Access Compliance Report

Public Rights-of-Way

(Curb Ramps)

Intersection ID: 3056	Main Street: BROWNE_RD	Cross Street: FOX_GLEN_RD	Location:	E
ADA ID: CA9DA3490759	Ramp Type: Perp	Initial Pass/Fail: Fail	Overall Compliance: No	Severity Score: 25
Codes/Mitigation Info/Possible Solution		Field Measurements/Component Compliance

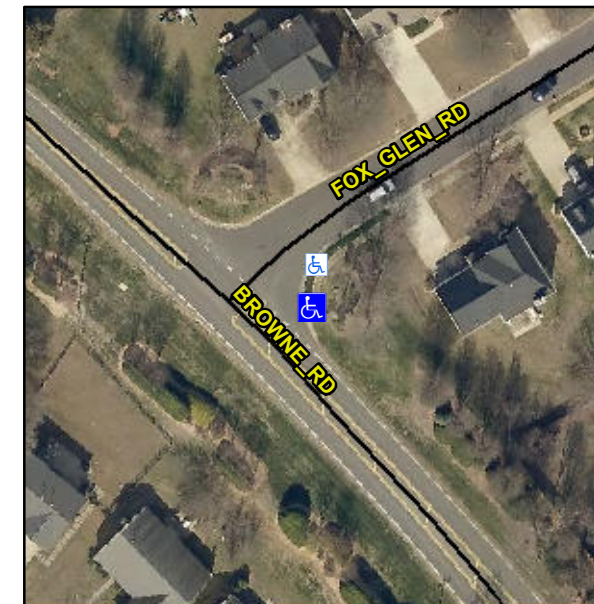
R304.2.2

Compliance	Description	Data	Compliance	Description	Data
N/A	Ramp Length (in)	49.0	No	Ramp Slope (%)	14.0
Yes	Ramp Width (in)	48.0	Yes	Ramp XSlope (%)	0.8
N/A	Flare Type LT	N/A	N/A	Flare Type RT	N/A
N/A	Flare Slope LT (%)	N/A	N/A	Flare Slope RT (%)	N/A
N/A	Flare Traversable LT?	N/A	N/A	Flare Traversable RT?	N/A
N/A	Landing Length (in)	N/A	N/A	DWS Provided?	N/A
N/A	Landing Width (in)	N/A	N/A	DWS Contrast?	N/A
N/A	Landing Slope (%)	N/A	N/A	DWS Length (in)	N/A
N/A	Landing X Slope (%)	N/A	N/A	DWS Full Width?	N/A
N/A	Landing Curb? (Y/N)	N/A	N/A	DWS Offset (in)	N/A
N/A	Shared Landing?	N/A			
N/A	Gutter Ponding?	N/A	N/A	Gutter Slope (%)	N/A
N/A	Gutter Lip Ht (in)	N/A	N/A	Gutter X Slope (%)	N/A
N/A	Painted X Walk1?	No	N/A	Painted X Walk2?	N/A
	X Walk 1 Direction	To SW		X Walk 2 Direction	N/A
N/A	X Walk 1 Width (in)	N/A	N/A	X Walk 2 Width (in)	N/A
	X Walk 1 Slope (%)	8.3		X Walk 2 Slope (%)	N/A
	X Walk 1 X Slope (%)	1.9		X Walk 2 X Slope (%)	N/A

Remove & Replace Entire Ramp.
